May 26, 2026

Re: Public Works Optimization-Design fee for development of revised Bid Package

Valdes Architecture & Engineering (Valdes AE) describes below, our proposal to the Village for design fees to amend the current set of public works optimization bidding documents.

1 SITE DEMOLITION PLAN
00.AD1-0
1" = 40'-0"

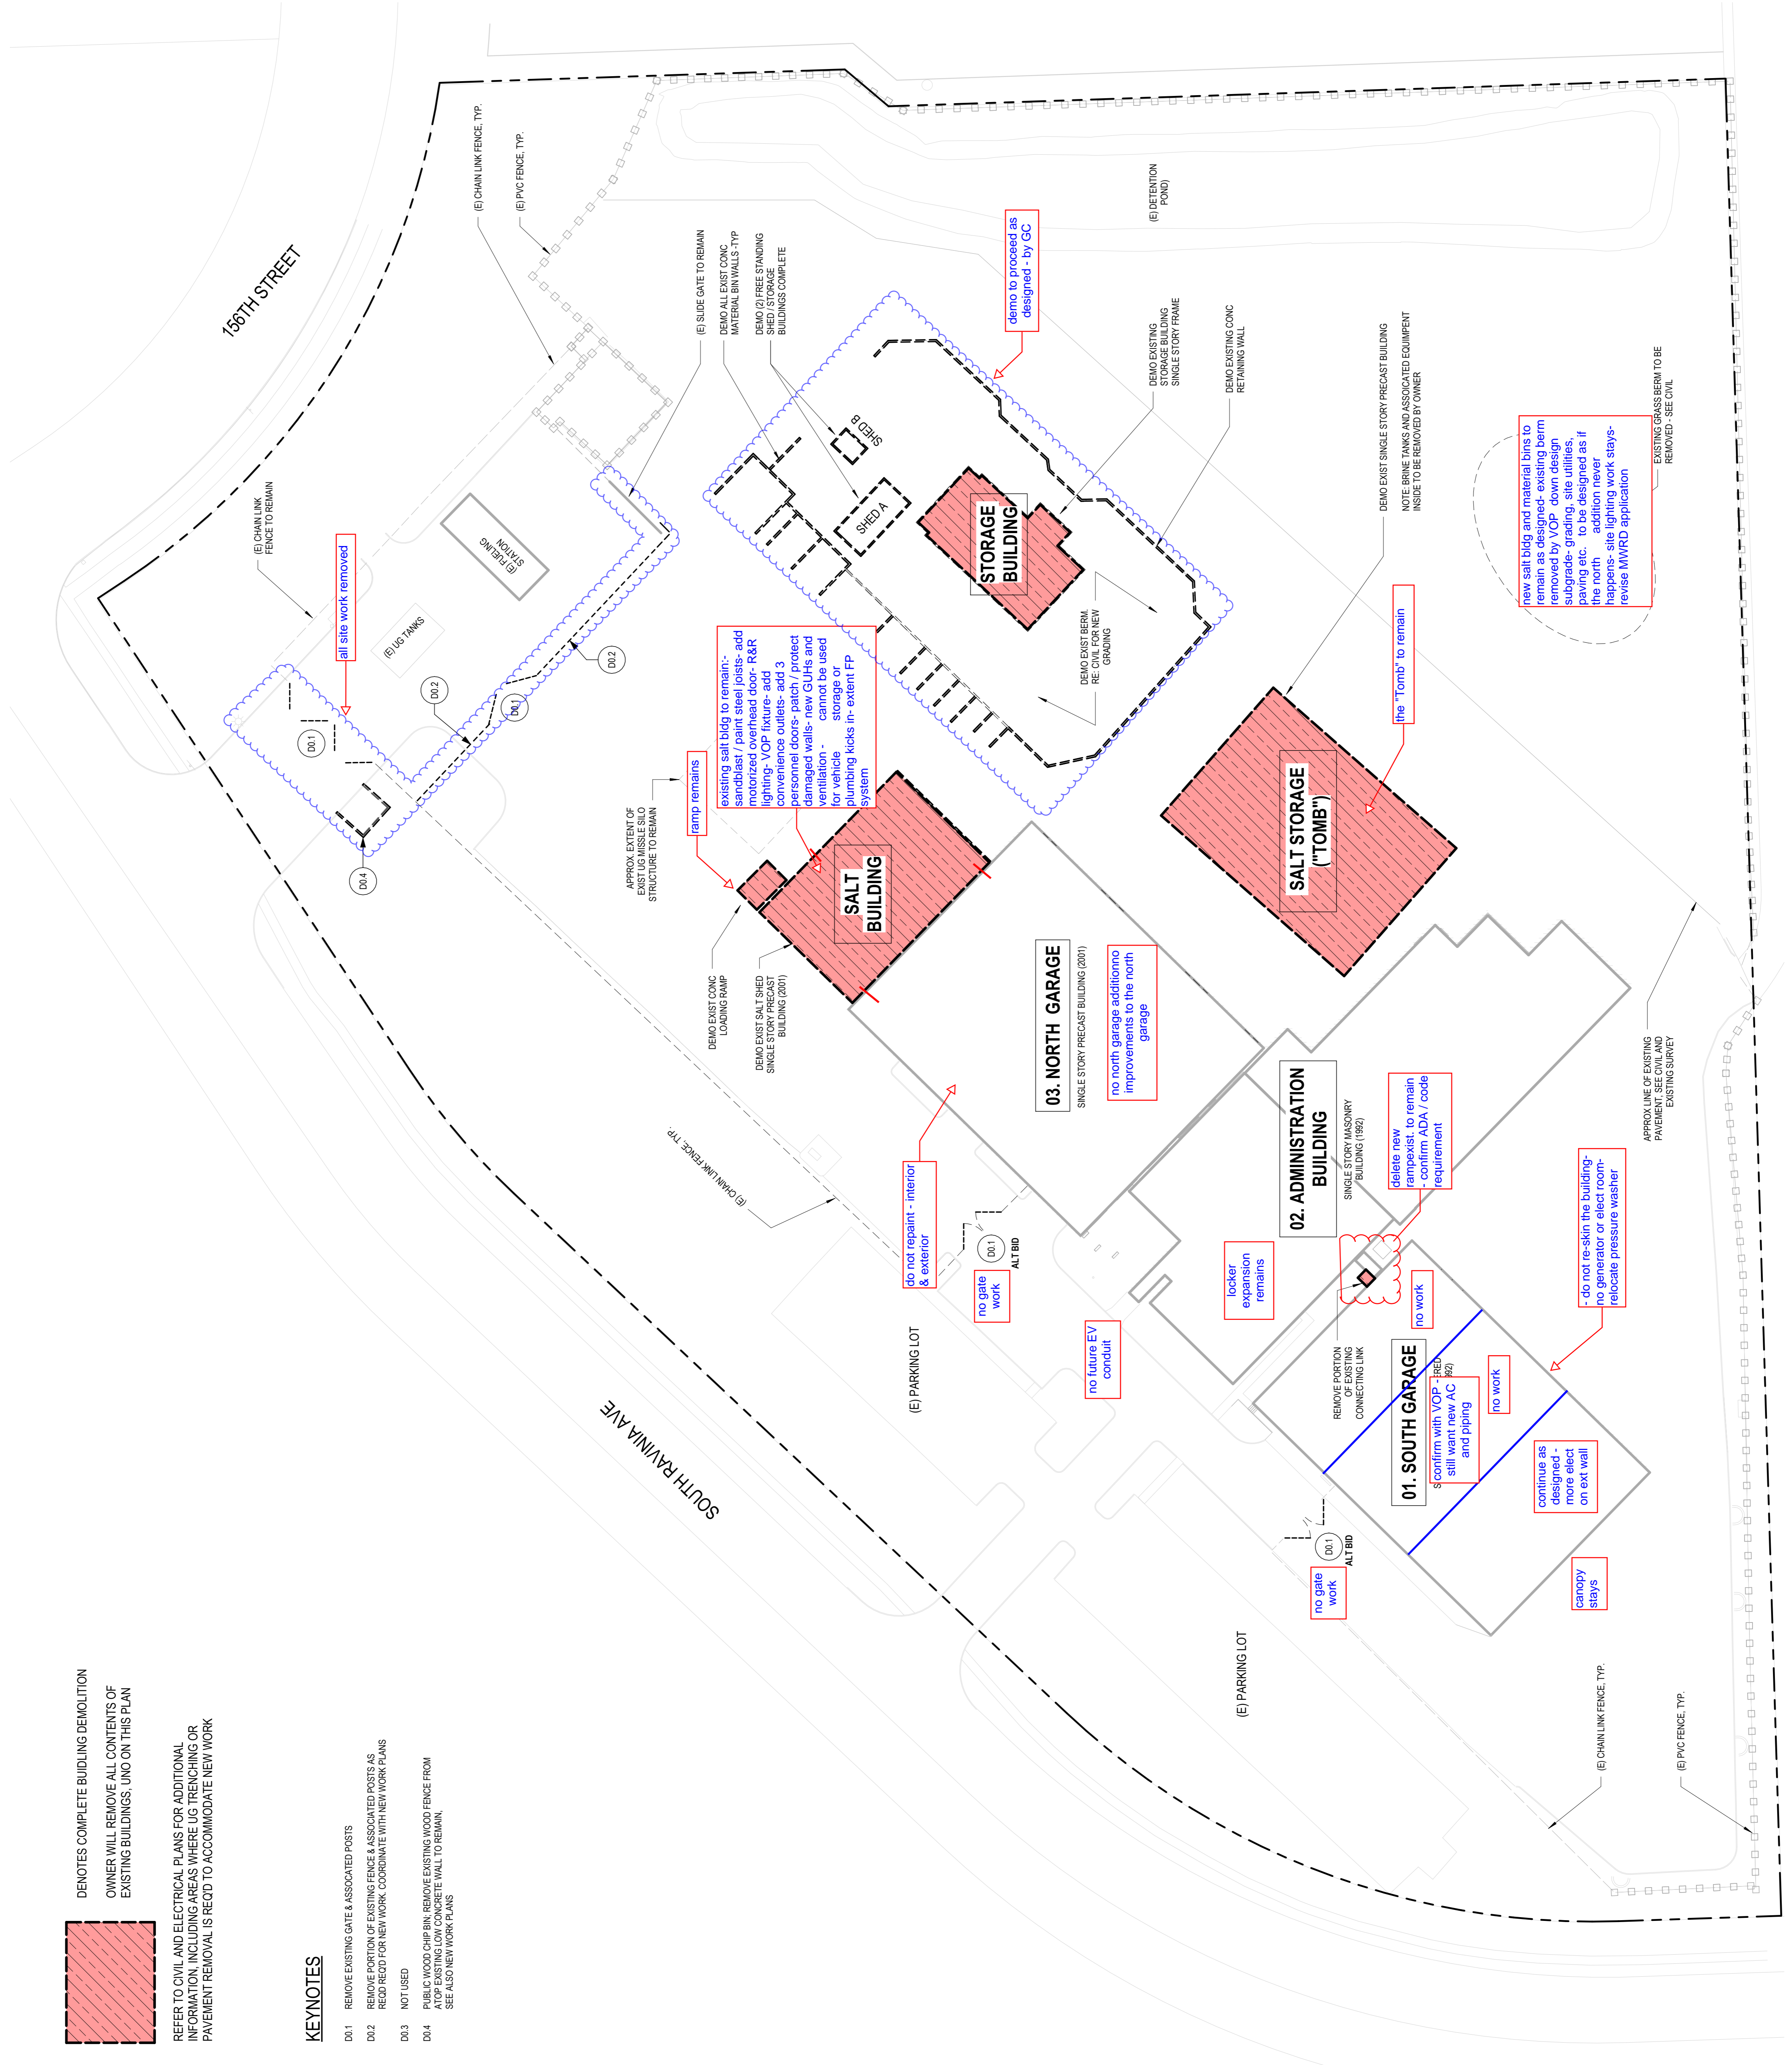
Description of Village requested scope changes from the current bidding document package (also see attached site plan):

EXISTING SALT BUILDING TO REMAIN AS DESIGNED - EXISTING TO BE
REMOVED BY VOP - down design,
subgrade, grading, site utilities,
paving etc. to be designed as if
the north addition never
happens - site lighting work stays
revis MWRD application
EXISTING CHAS BEING TO BE
REMOVED - SEE CIVIL
